ADDENDUM No. 2

Date November 20, 2012

Project Name North Walnut Creek Bike Trail Improvements

C.I.P. No. 5261.001

**Structural Plan & Profile
 Bridge #6B**

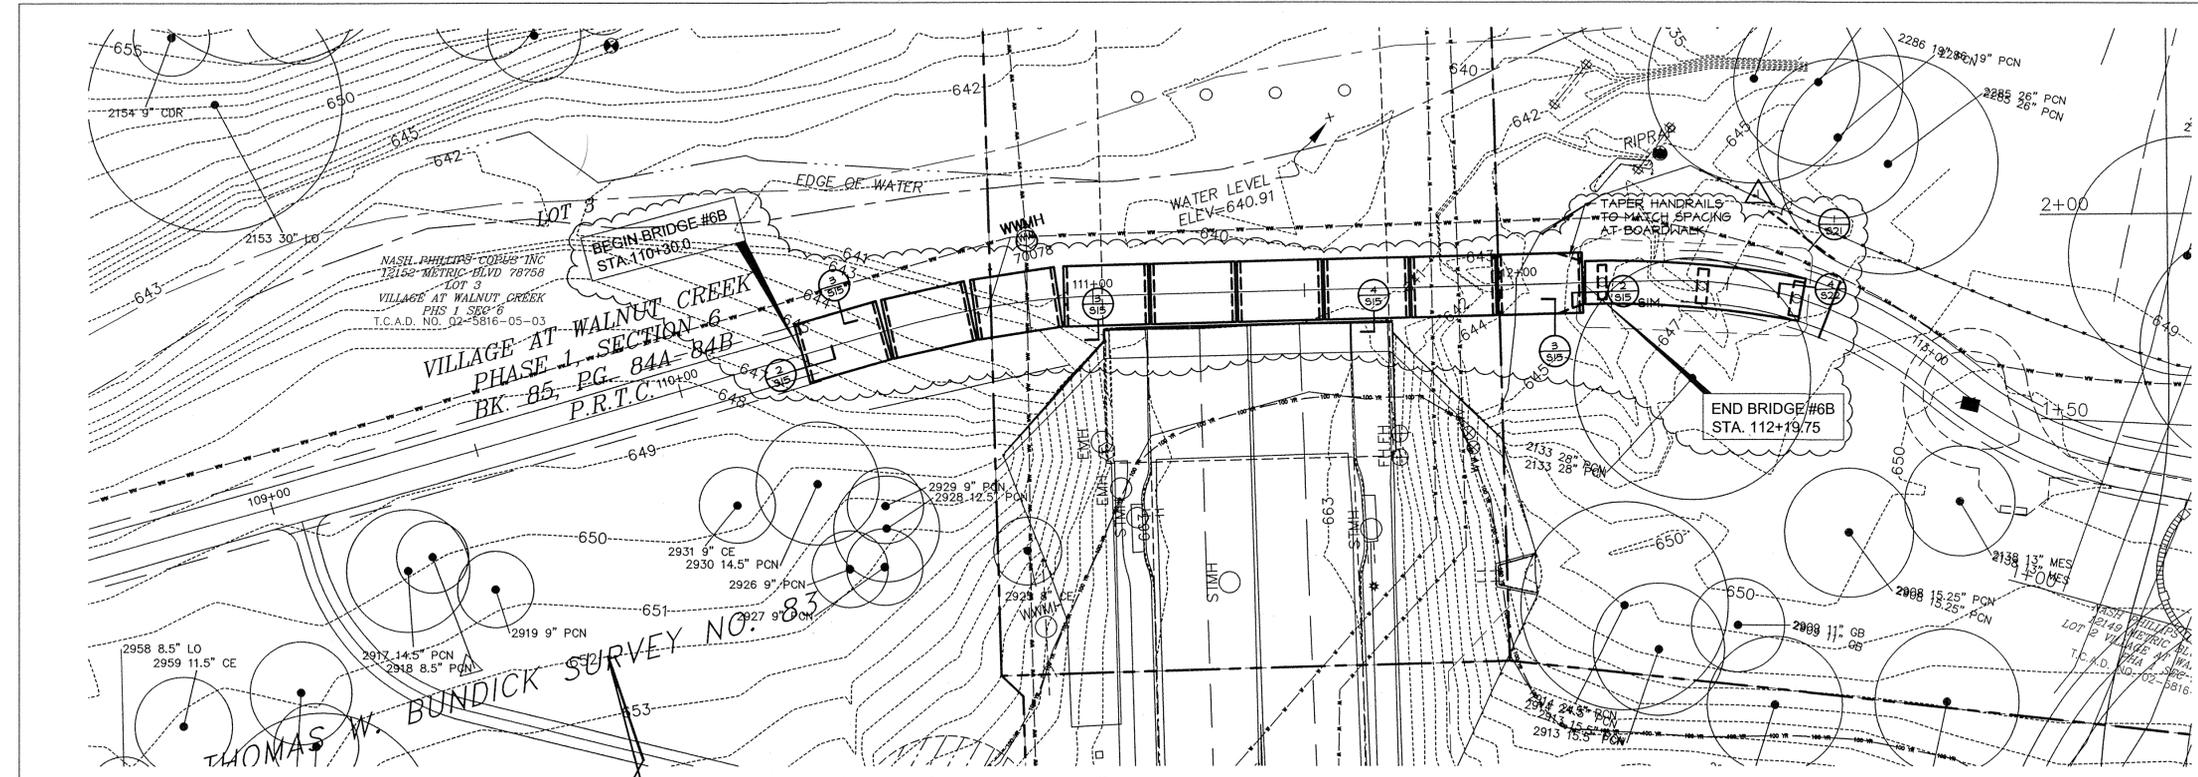
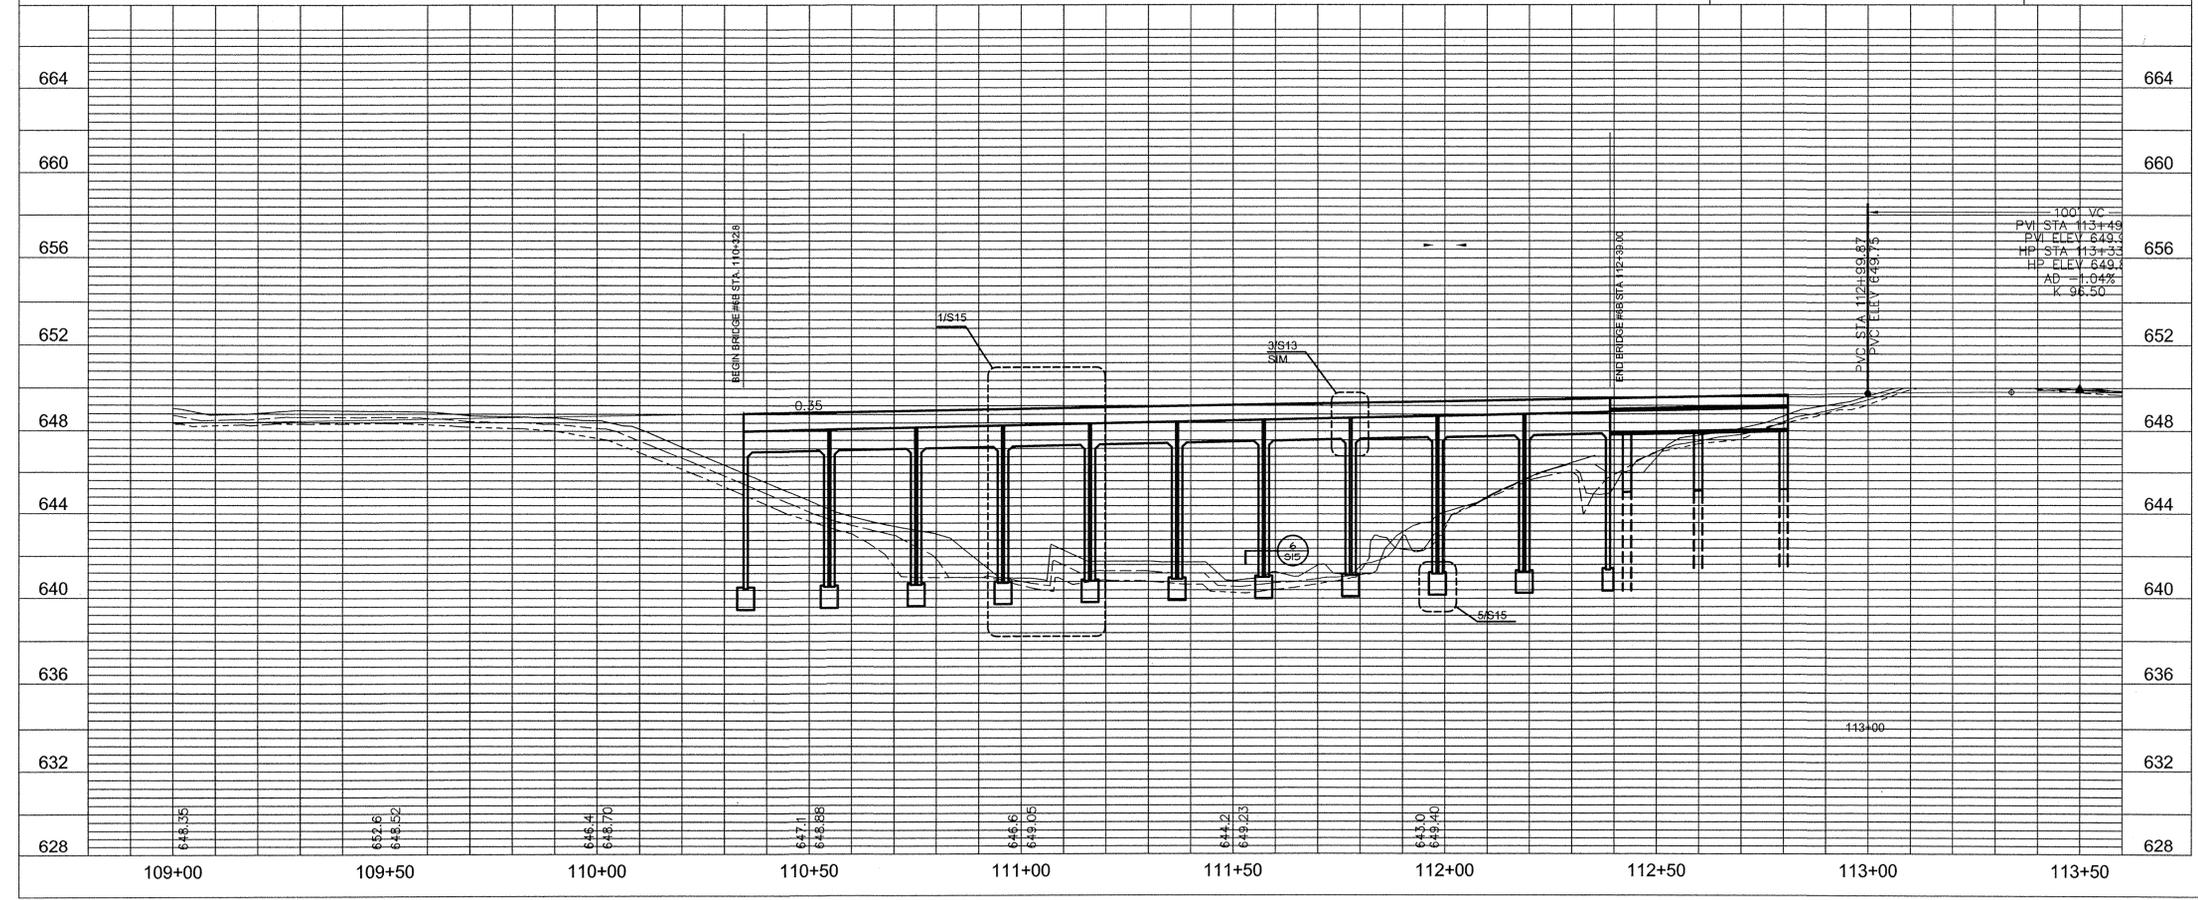
4. Sheet S7 (Sheet 155 of 213), remove existing sheet and replace with provided sheet.
5. Sheet S21 (Sheet 169 of 213), remove existing sheet and replace with provided sheet.

Boardwalk Details

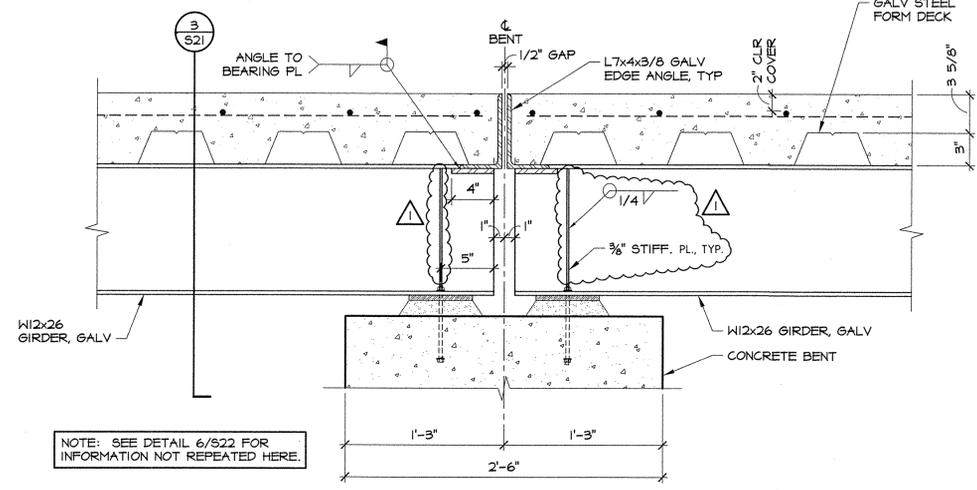
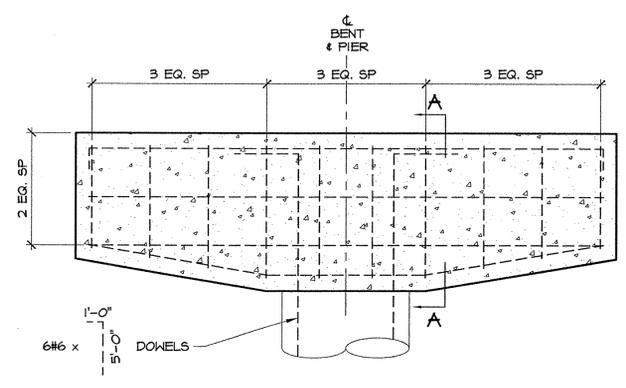
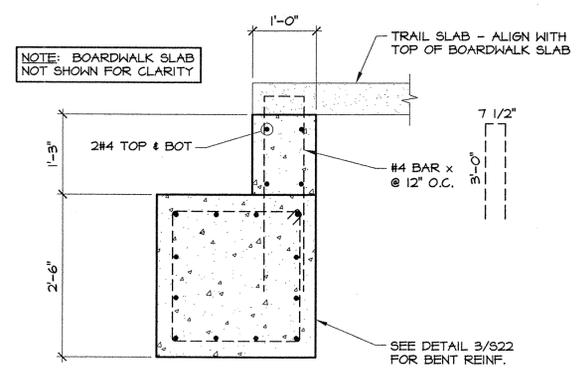
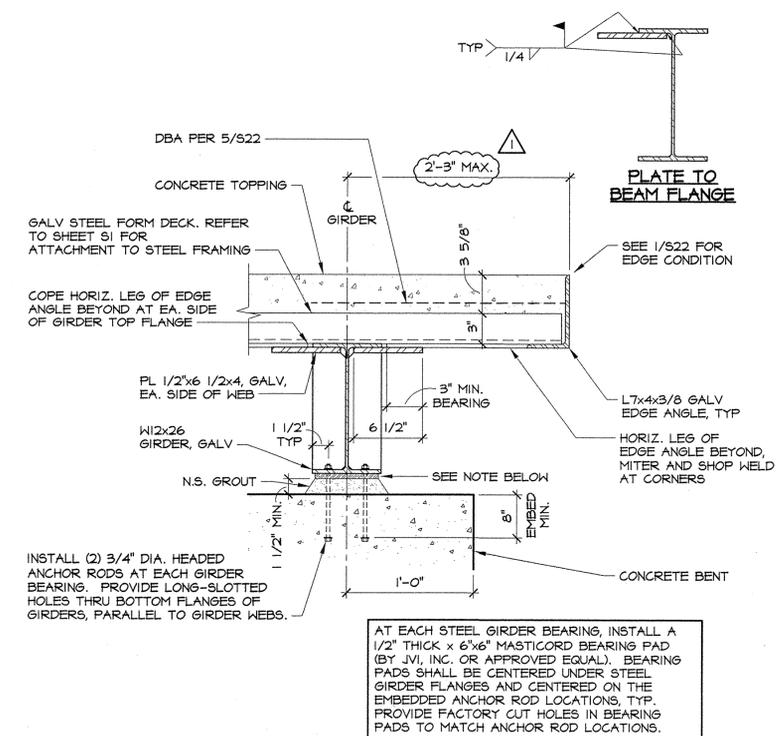
6. Sheet S22 (Sheet 170 of 213), remove existing sheet and replace with provided sheet.
7. Sheet S1 (Sheet 149 of 213), add the following chart, "Estimate of Main Channel Flow Velocity." The corrected sheets to be provided after contract award.
